Intermittent Starter Solenoid

EFFECTIVITY**MODEL-** Ranger R7**SERIAL NO:** ALL AIRCRAFT IN THE RANGE: **10206-10216****REASON**

SB-10-16-23-1 REV A
Page 1 of 2

Appendix A: Replacement of Starter Solenoid

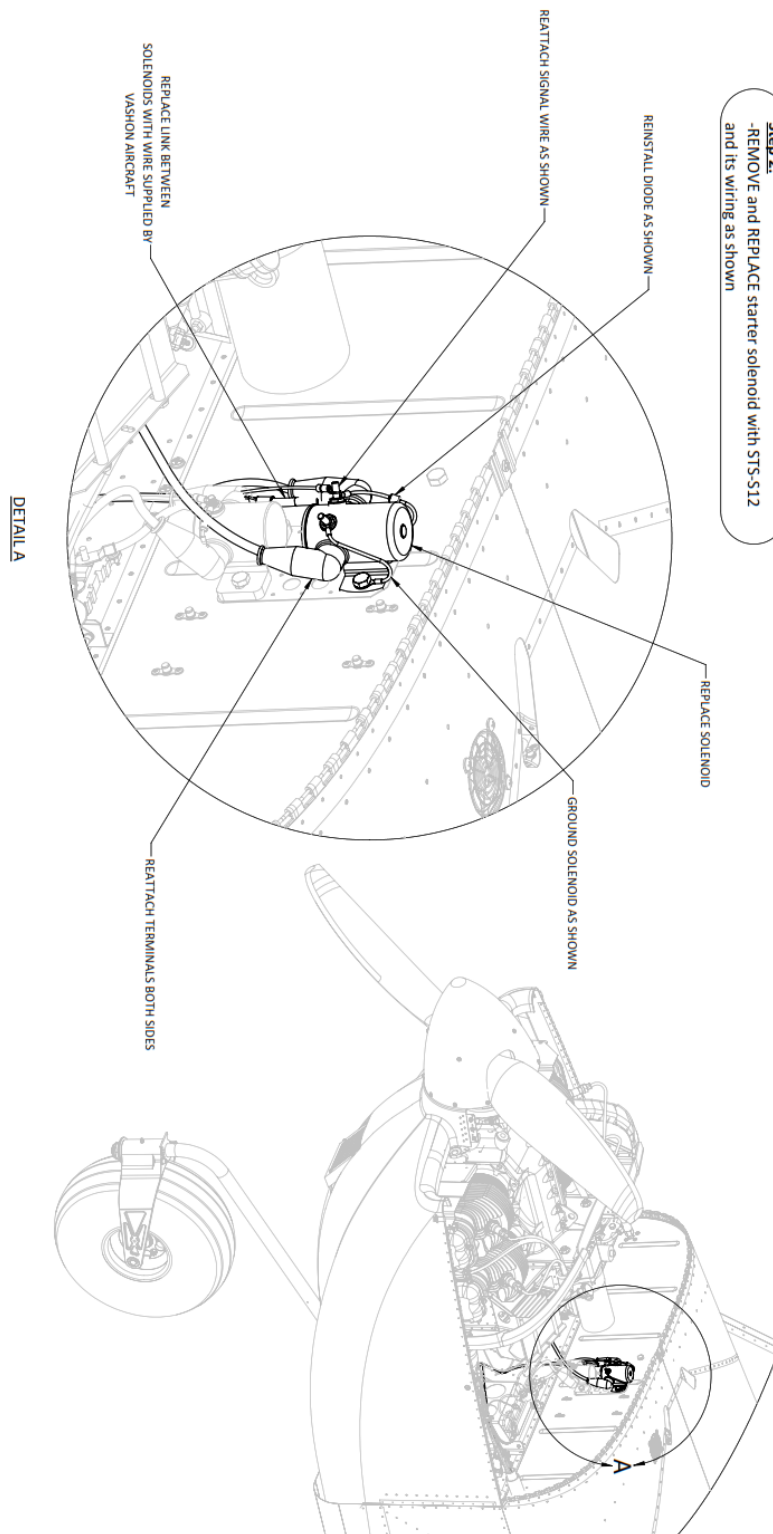
A batch of starter solenoids is susceptible to being engaged unexpectedly and powering the starter motor. This is due to Vashon Aircraft purchasing this component from a different manufacturer which appears to have looser tolerances between the electrical connections. If this poorer quality solenoid accidentally engaged, the propeller would start spinning when power is provided with the master switch. That is regardless of if keys are in the ignition or not.

Replace solenoid.

Replace the starter solenoid with parts supplied by Vashon Aircraft. The promptest response can be obtained by contacting Vashon Aircraft.

Step 1:
-DETACH battery positive terminal

Step 2:
-REMOVE and REPLACE starter solenoid with STS-S12 and its wiring as shown
